Access Compliance Report

Public Rights-of-Way

(Curb Ramps)

Intersection ID: N/A	Main Street: E_3RD_ST	Cross Street: S_CALDWELL_ST	Location: W
ADA ID: 824C0D86CF87	Ramp Type: Perp	Initial Pass/Fail: Pass	Overall Compliance: No
Severity Score: 0.25			
Codes/Mitigation Info/Possible Solution		Field Measurements/Component Compliance

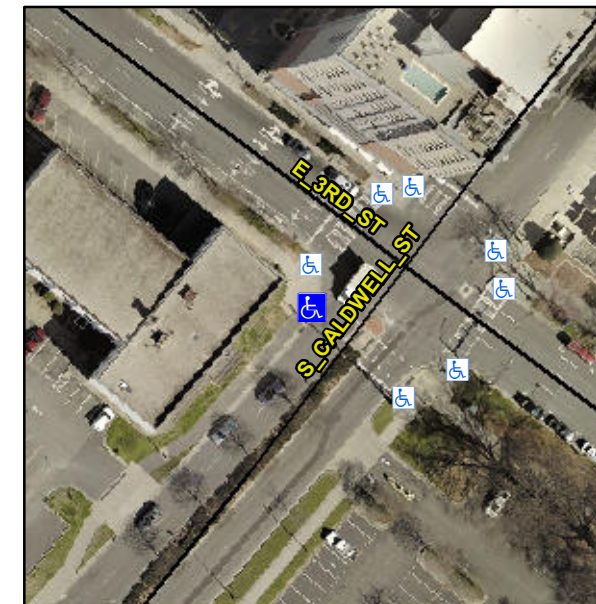
Not Found, R304.2.2-Perp, R304.3.2-Para

Remove & Replace Entire Ramp.
